Heritage Vaughan Committee
Wednesday, March 24, 2021
7 pm

**Item 3. Renovation of Existing Heritage House, and Rear Addition at 7714 Yonge Street, Thornhill
Heritage Conservation District**

Figure 6: A circa 1900 street view with the fence, ditch, and boardwalk of the property at far left (courtesy City of Vaughan Archives).

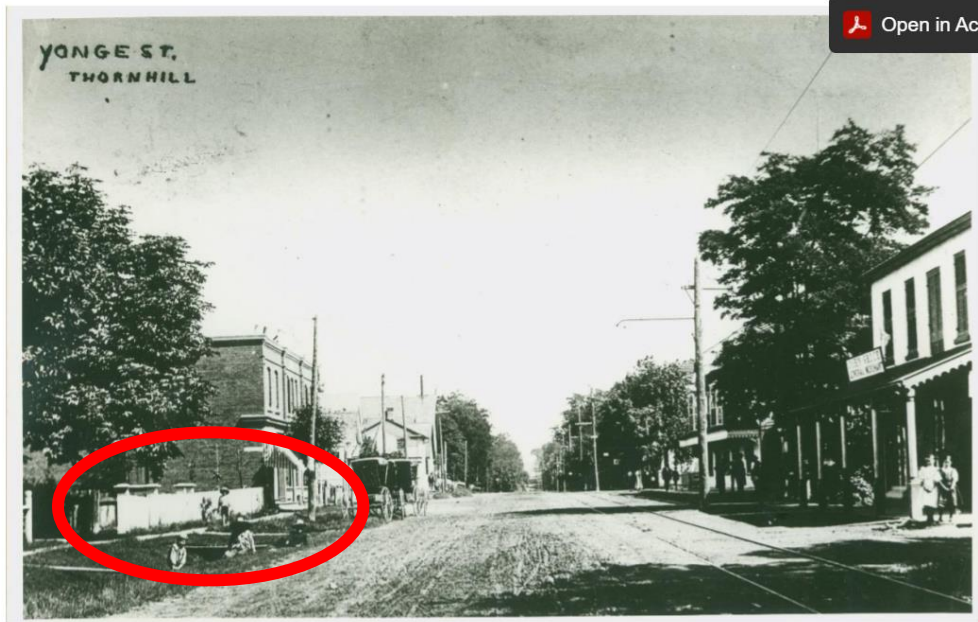
- **Glass Railings** - I am concerned about the modern appearance of these railings and potential deaths/injuries to birds colliding with the glass. I recommend that the glass railings be replaced with a white picket fence. Also, a white picket fence should be installed along the Yonge Street frontage to enhance the historic ambiance. A white picket fence did exist along the Yonge Street frontage as per the attached Figure 6 illustration.
